## **NOTICE OF A TYPE II DECISION ON A PROPOSAL IN YOUR NEIGHBORHOOD**

### **CASE FILE NUMBER: LU 09-101165 DZ, ROSE QUARTER HOUSING RENOVATION REVISION**

The applicant is in the process of renovating a building, changes are proposed to the previous land use review processed under LU 08-131693 DZM. Amongst the proposed changes are the following:

LU09-101165D2  
 Exhibit C-2

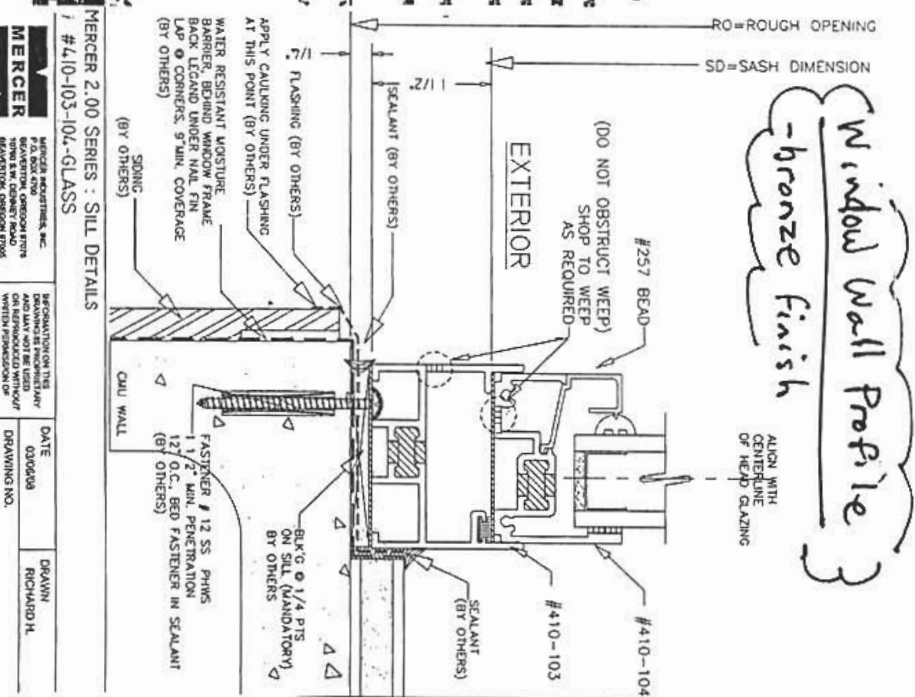
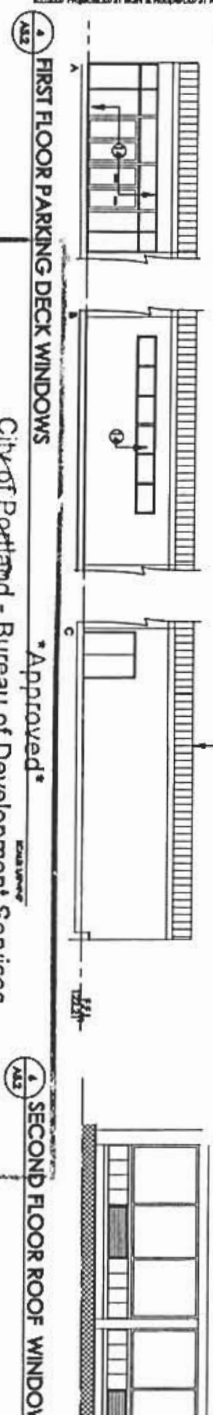
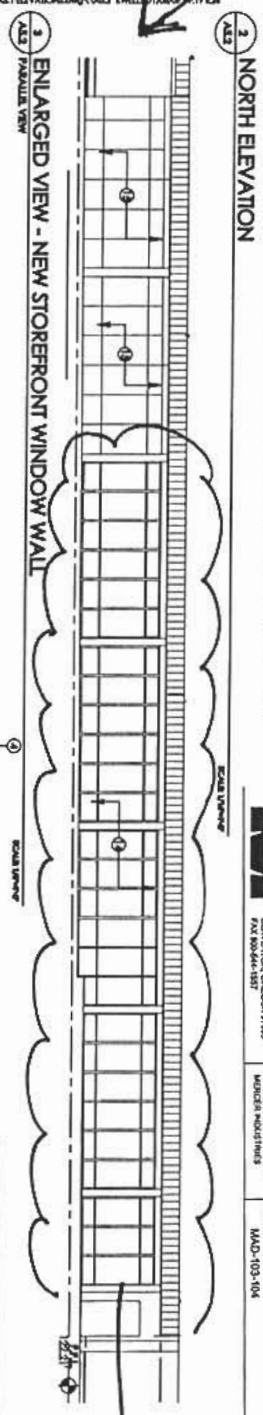
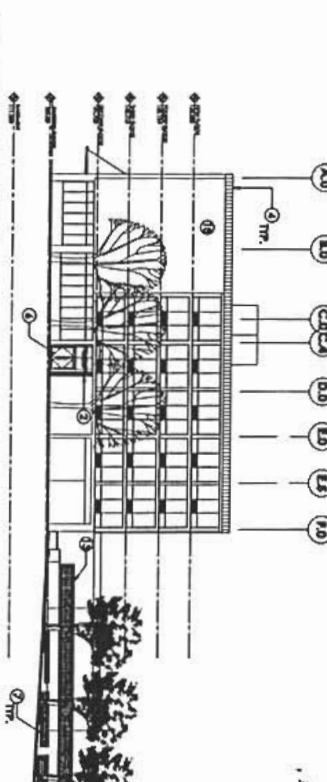
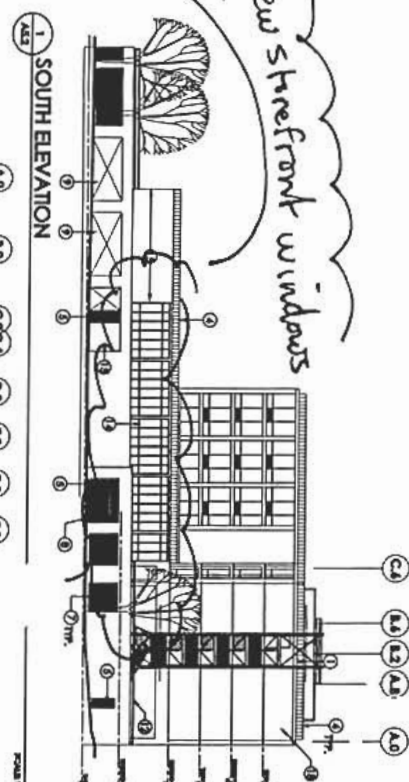
New storefront windows

Window Wall Profile  
-brnze finish

1 WEST ELEVATION

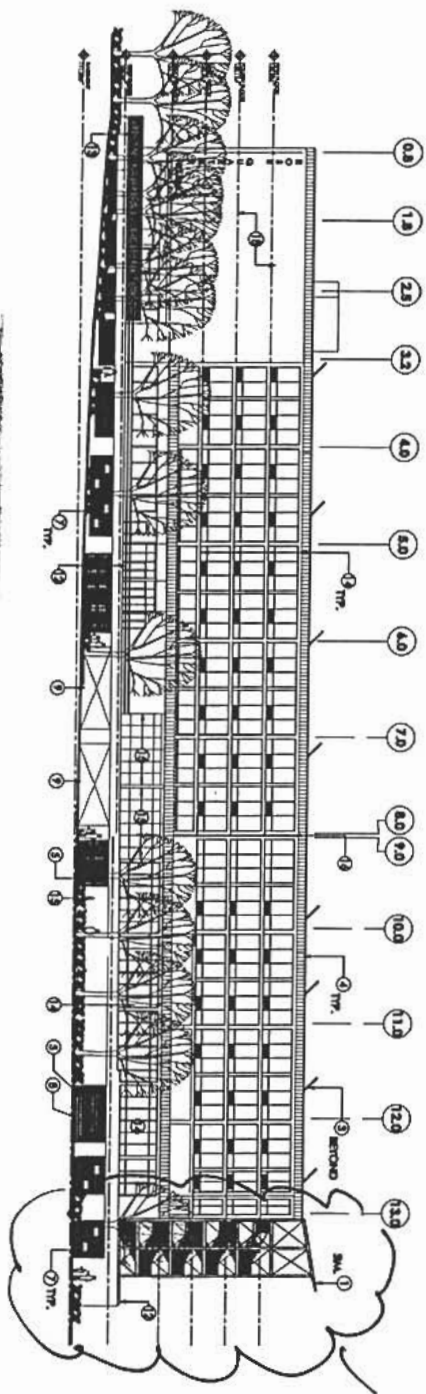
modified  
slope roof  
to stair  
tower

A5.1

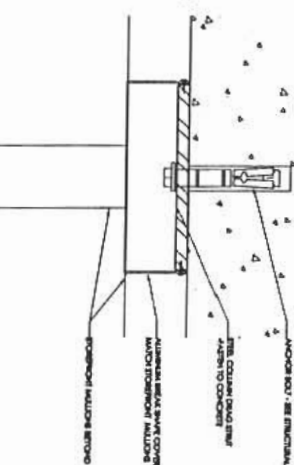
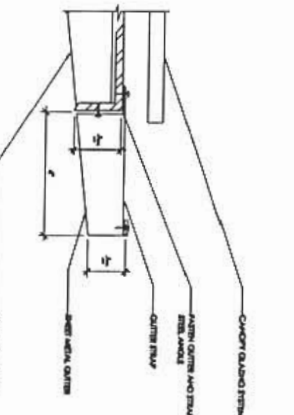
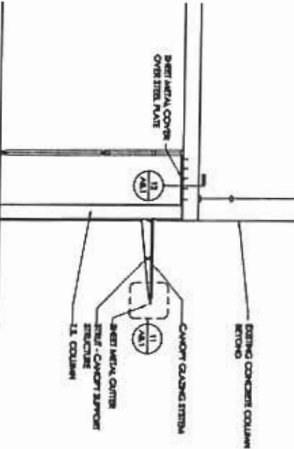
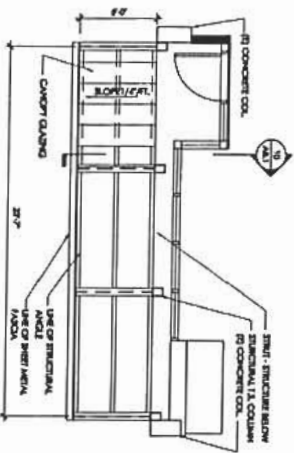
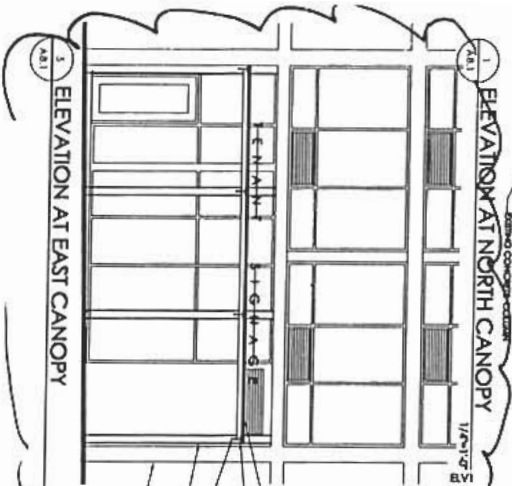
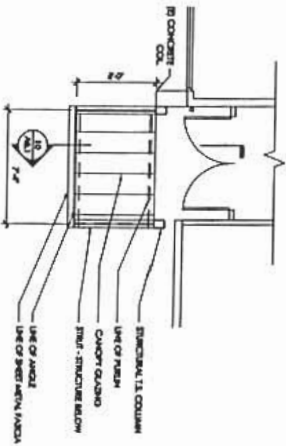
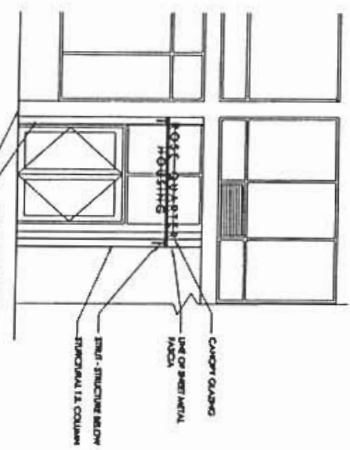
slight canopy modification

L009-10186 SDZ exhibit C.6

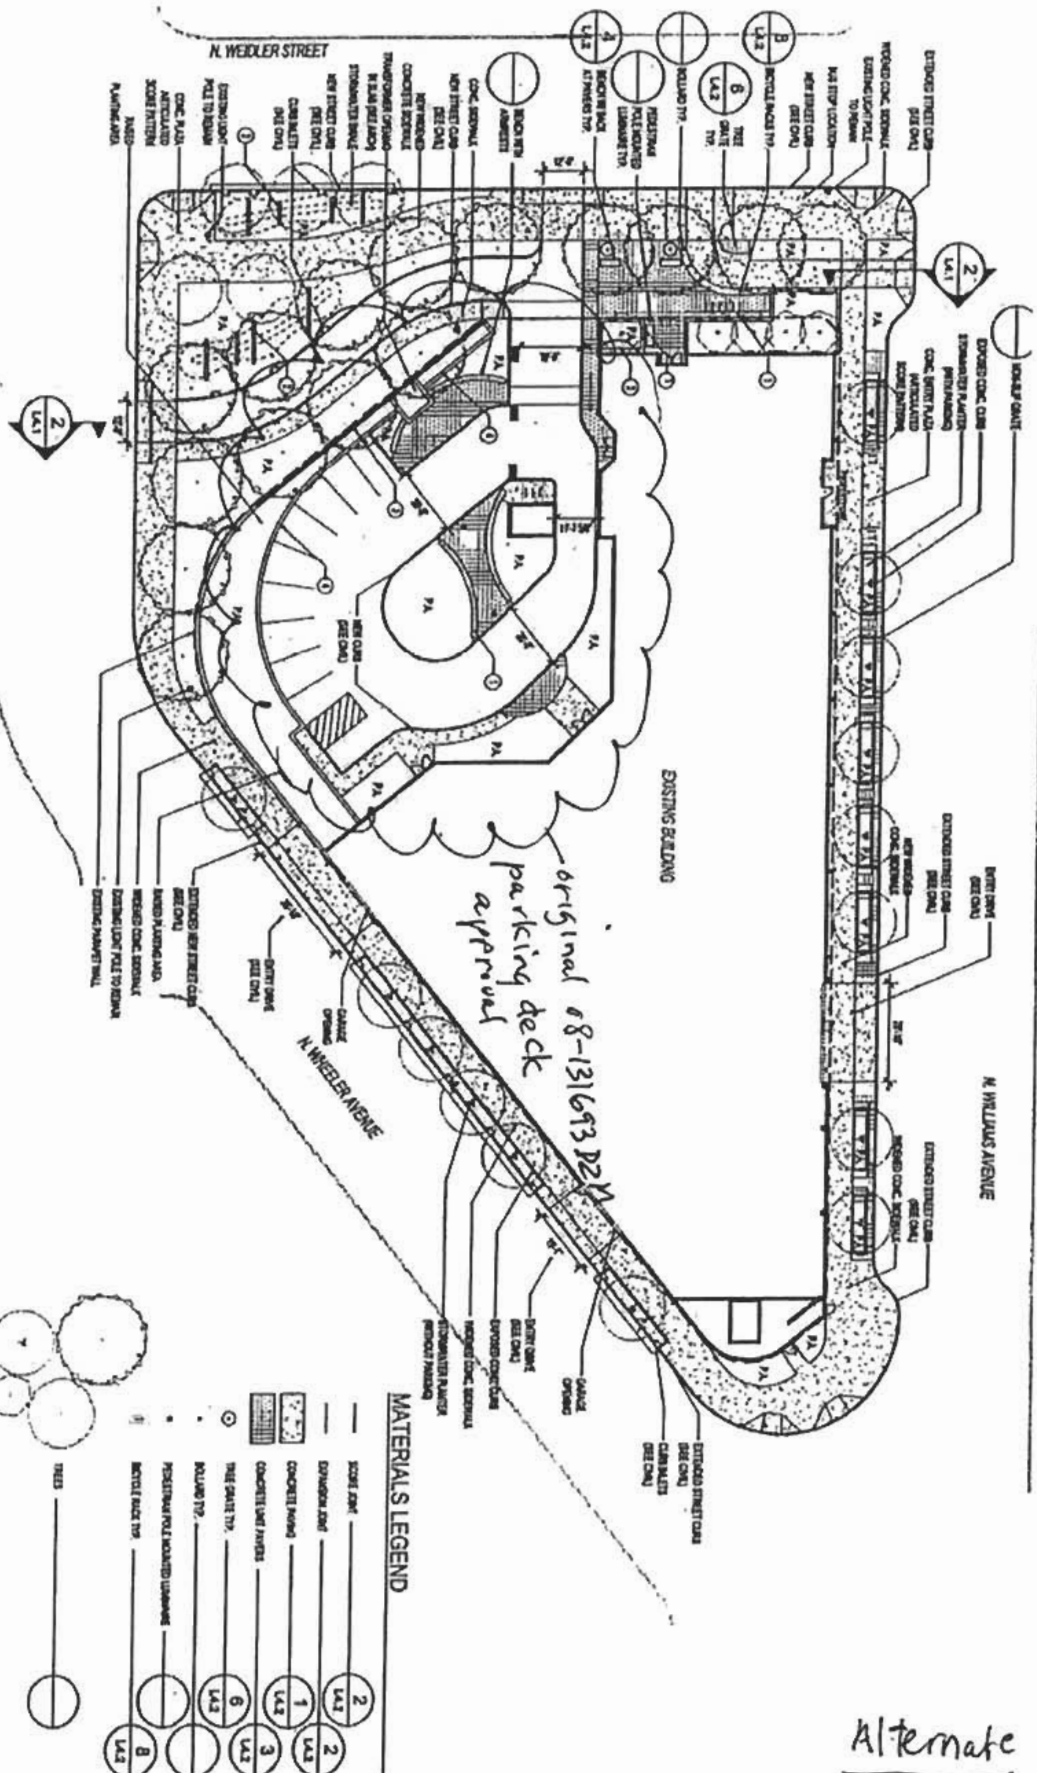
Alternate
